STATE OF CONNECTICUT  
CONNECTICUT SITING COUNCIL

APPLICATION OF MESSAGE CENTER  
MANAGEMENT, INC. (MCM) AND NEW CINGULAR  
WIRELESS (AT&T) FOR A CERTIFICATE OF  
ENVIRONMENTAL COMPATIBILITY AND PUBLIC  
NEED FOR THE CONSTRUCTION, MAINTENANCE  
AND OPERATION OF A TELECOMMUNICATIONS  
TOWER FACILITY IN REDDING, CONNECTICUT

DOCKET NO. 449

RESPONSES OF MESSAGE CENTER MANAGEMENT  
AND NEW CINGULAR WIRELESS  
TO CONNECTICUT SITING COUNCIL PRE-HEARING QUESTIONS, SET I

- Green:  $\geq -83$  dBm
- Orange:  $< -83$  dBm &  $\geq -93$  dBm
- White:  $< -93$  dBm

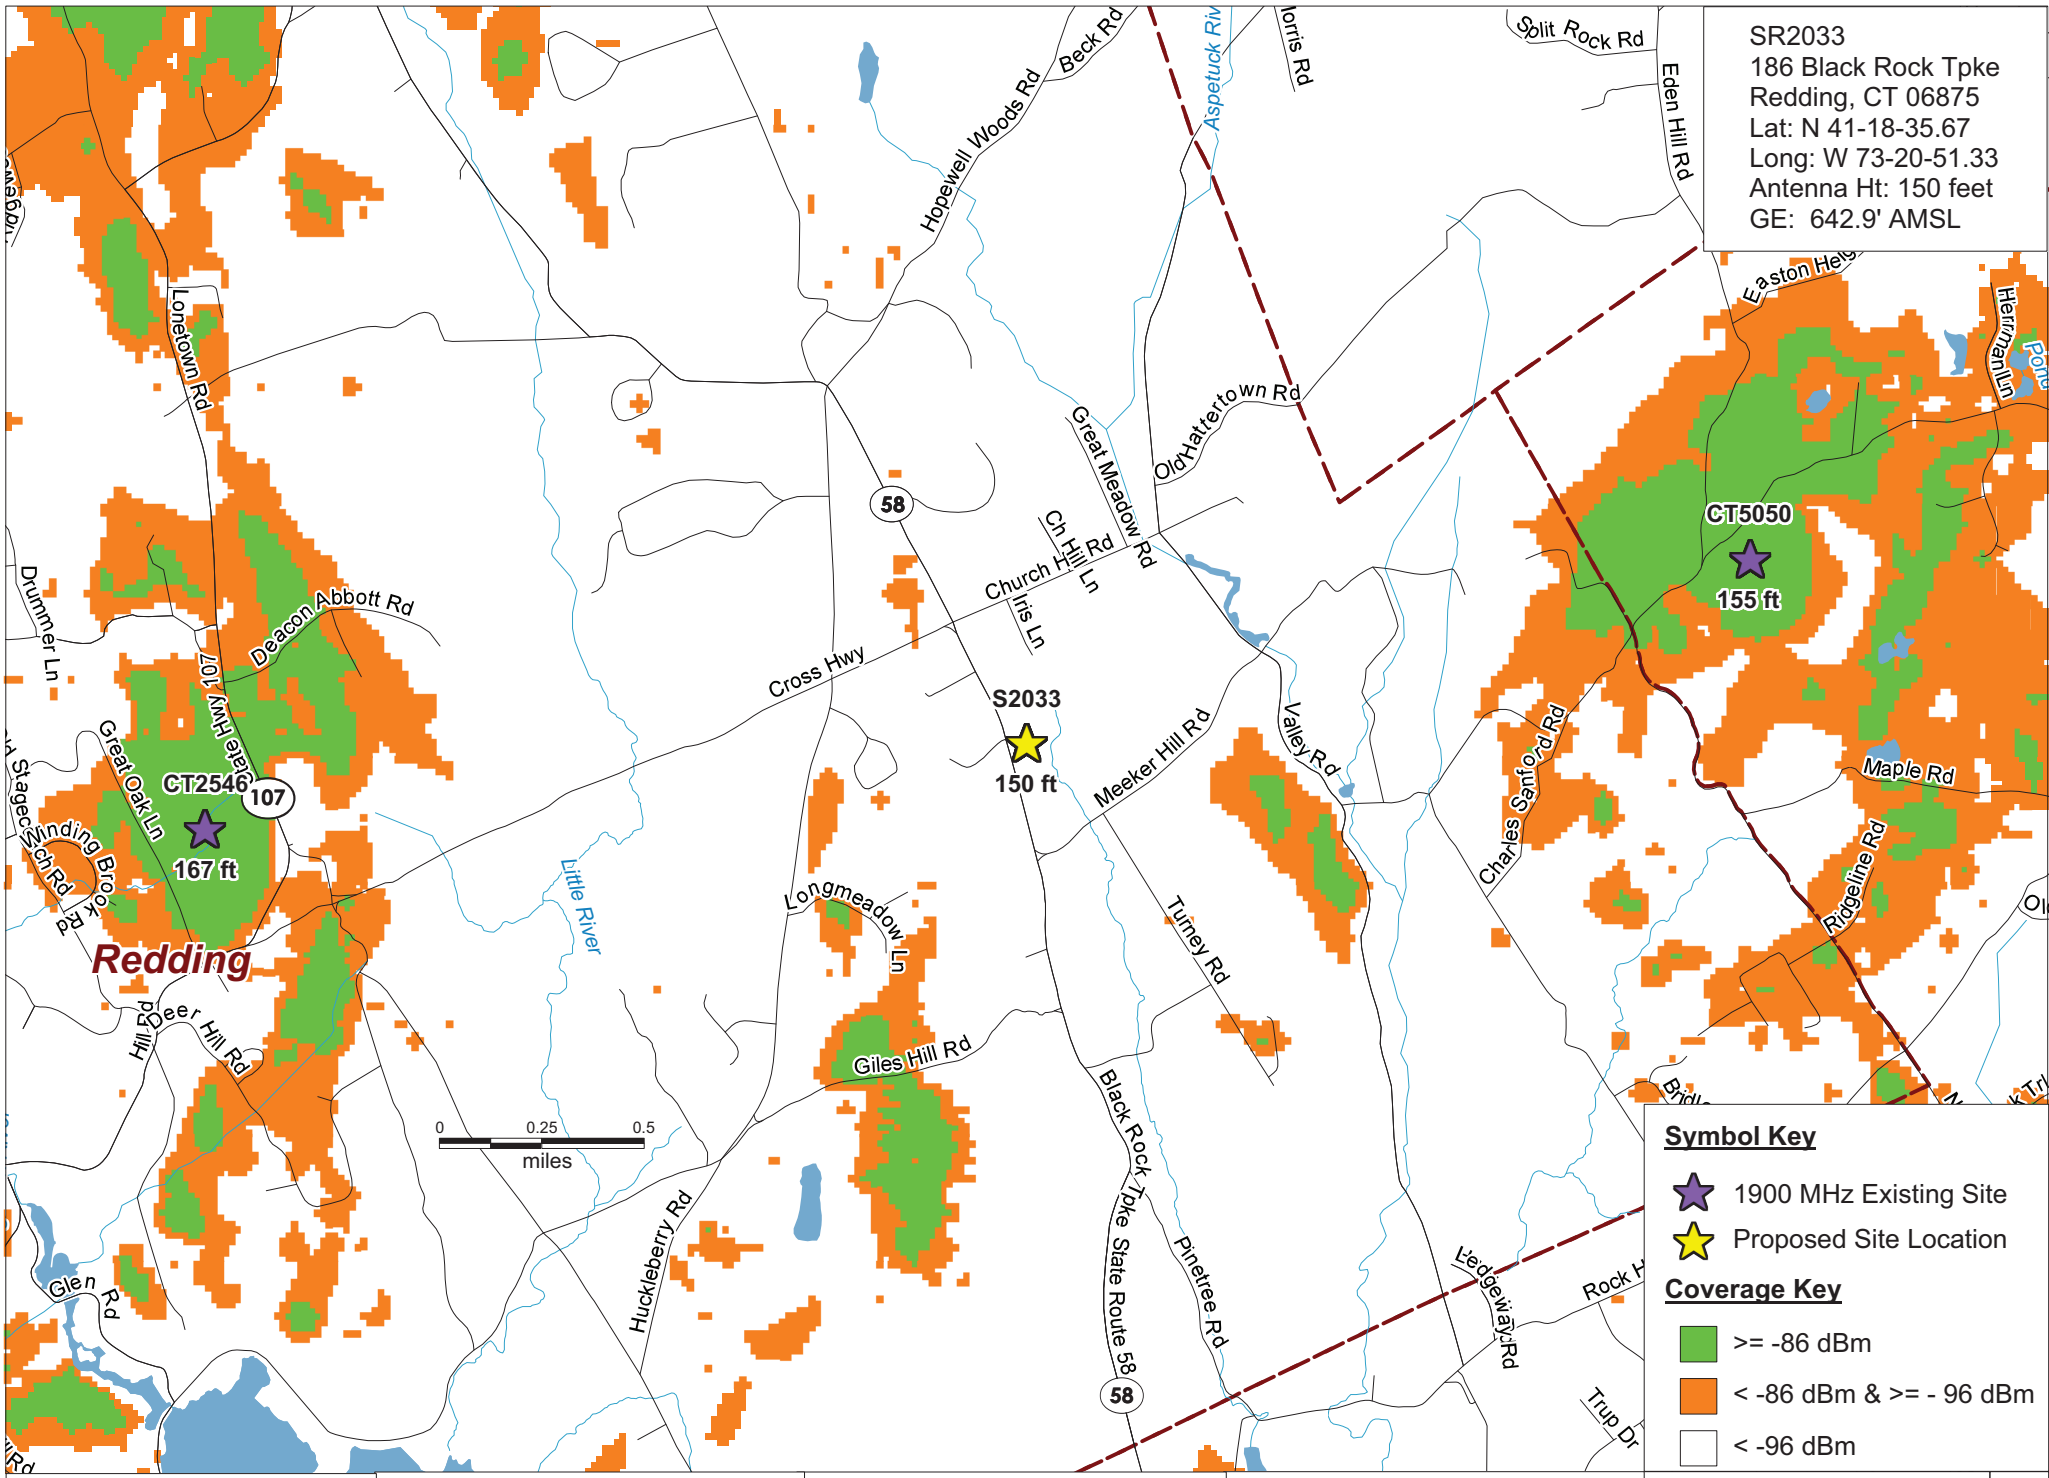
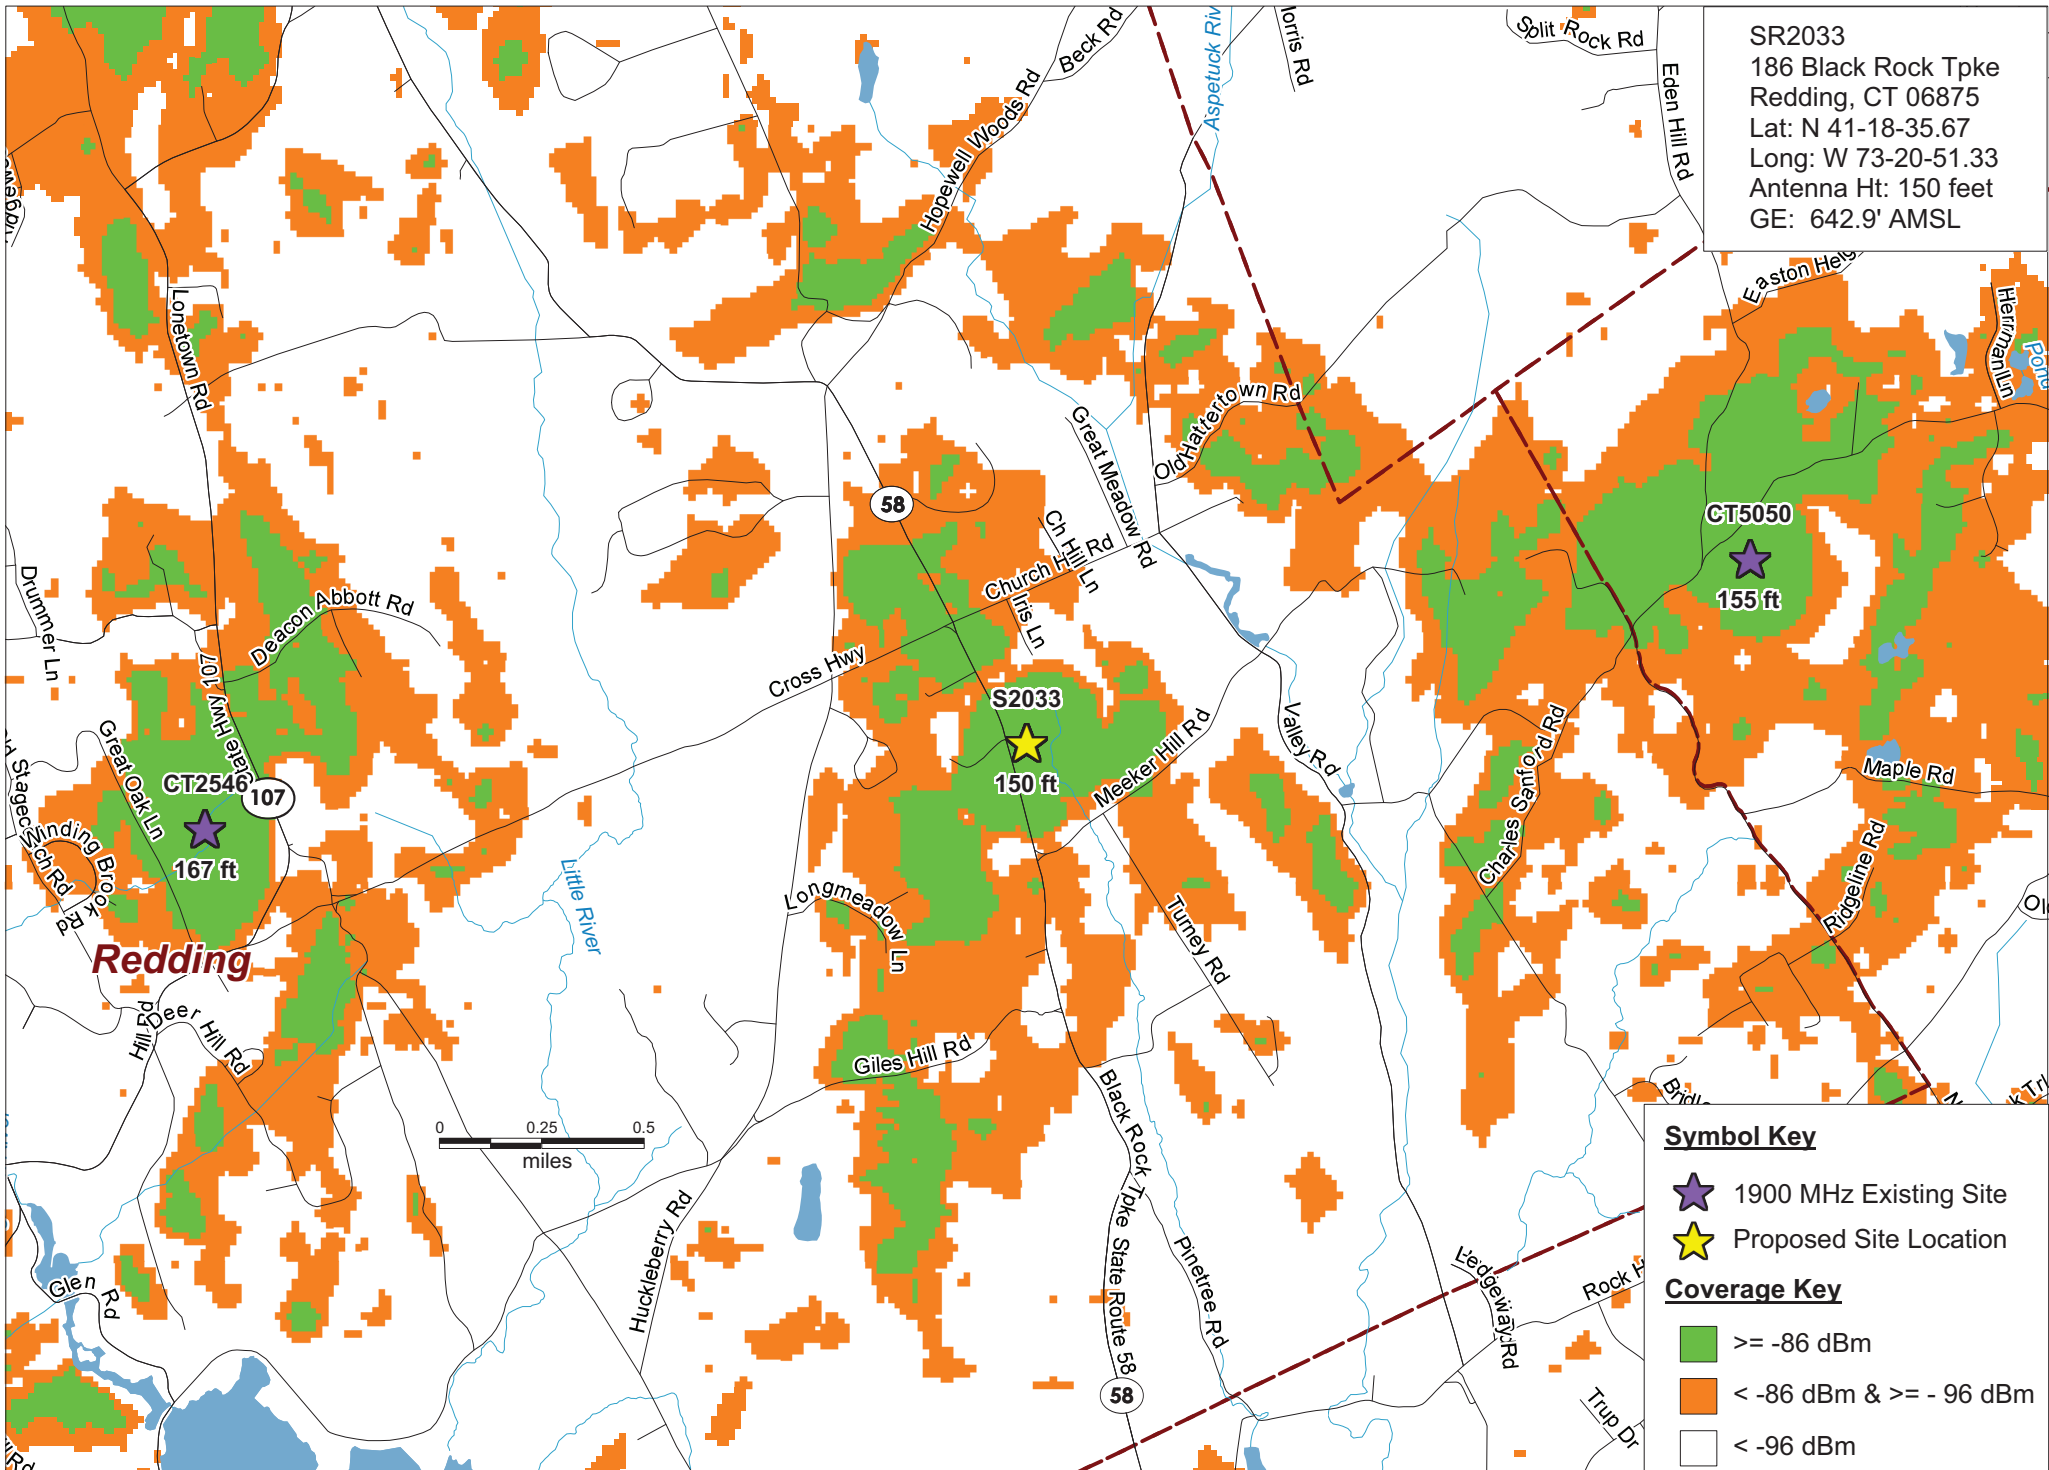
- Q27. In the Radio Frequency Analysis Report (RF Report) under Tab 1 of the Application, AT&T included an existing coverage plot and an existing and proposed coverage plot for 850 MHz. Provide a similar plots for 700 MHz and 1900 MHz or other frequencies as applicable. Also provide a replacement existing coverage plot for 850 MHz identifying the proposed site location on the plot.

- A27. *Please see plots included in Attachment 4.*
